**Amendments to the Drawings**

The attached sheets of drawings include changes to Figs. 2B, 5, 12, 13, 18, 19, and 27. These sheets replace the original sheets including Figs. 2A, 2B, 5, 12, 13, 18, 19, and 27. These figures are amended in response to the Examiner's objection as discussed in the Remarks.

## REMARKS

Fig. 2B

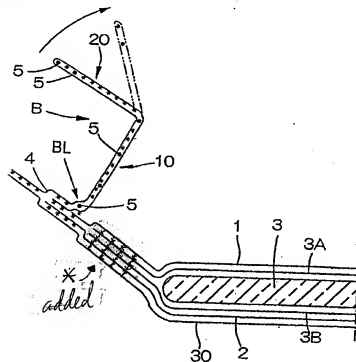
Comment 5: "Structure which is the same in various should be shown consistently, e.g. see the fixing /adhesive shown by asterisks ... which does not show such" (page 3, lines 12-14 of the Office Action).

Asterisks are added to Fig. 2B in the same manner as Fig 2A.

Fig. 12

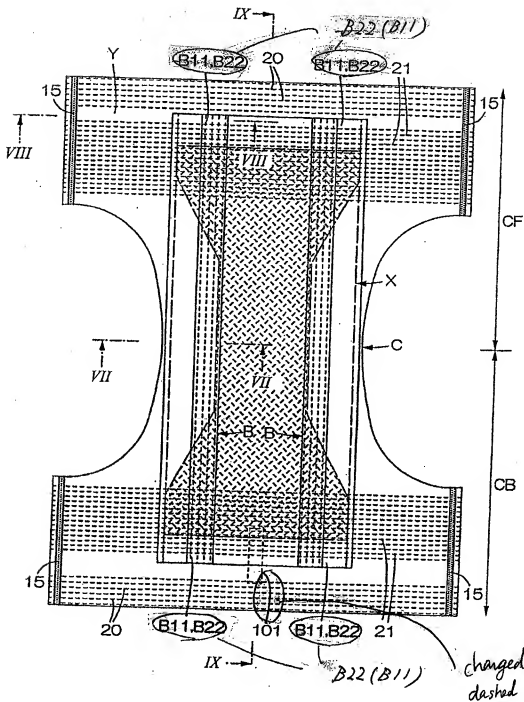
Comment 1: “no numerals separated by commas as seen in Figures 12 and 13” (page 3, lines 6-7 of the Office Action)

Comment 4: "outlines of structure underlying other structure and lines from numerals denoting such structures should be dashed e.g. the line from 101 in Figure 12 and 100 in Figure 18 should be dashed" (page 3, lines 10-12 of the Office Action).

Fig. 12, “B11, B22” is changed to --B22 (B11)--. B11 designates extension of standing portion B1 while B22 designates extension of the contacting portion. In Fig. 12, extension B22 is folded back and inverted so as to be fixed on extension B11.

First, numeral 100 in Fig. 18 is changed to --101--. Second, the lines identified by the Examiner are changed to the dashed lines. Numeral 101 designates an after-treatment tape provided on the back surface of the overall sheet Y.
